Project	IEEE 802.16 Broadband Wireless Access Working Group < http://ieee802.org/16 >	
Title	Service Primitive for Paging Group Action	
Date Submitted	2005-07-12	
Source(s)	Jee Hyeon Na, Yun Won Chung, PhD Sang Ho Lee, PhD ETRI, 161, Gajeong-dong, Yuseong-gu, Daejeon, 305-700, Korea	jhna@etri.re.kr yun.chung@etri.re.kr leesh@etri.re.kr Voice: +82-42-860-5408 Fax: +82-42-861-1966
Re:	Call for Comment on P802.16g Baseline Document	
Abstract	This contribution proposes service primitive for paging group action	
Purpose	The document should be considered during the resolution of comments on the baseline document.	
Notice	This document has been prepared to assist IEEE 802.16. It is offered as a basis for discussion and is not binding on the contributing individual(s) or organization(s). The material in this document is subject to change in form and content after further study. The contributor(s) reserve(s) the right to add, amend or withdraw material contained herein.

Service Primitive for Paging Group Action

[Modify section 14.5.9.2 as follow]

Fig. 2 - Paging Group Action Procedures

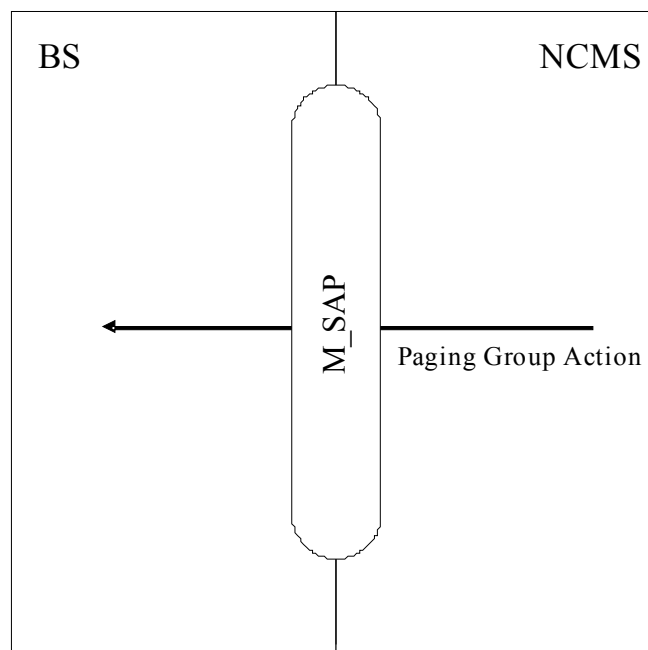
The location information of an idle MSS is managed by the unit of Paging Group in Paging Service of an NCMS, and paging messages are sent to all the BSs within the called MSS's Paging Group. The NCMS should divide the whole service area into multiple Paging Groups and notify this Paging Group information to all the BSs within the service area, where a BS may be a member of one or more Paging Groups. In this contribution, we propose service primitive for Paging Group Action which are exchanged through Management Service Access Point (M-SAP) of Management Plane specified in IEEE 802.16g baseline document. Paging Group Action is performed by Paging Service of an NCMS, as shown in Fig. 2
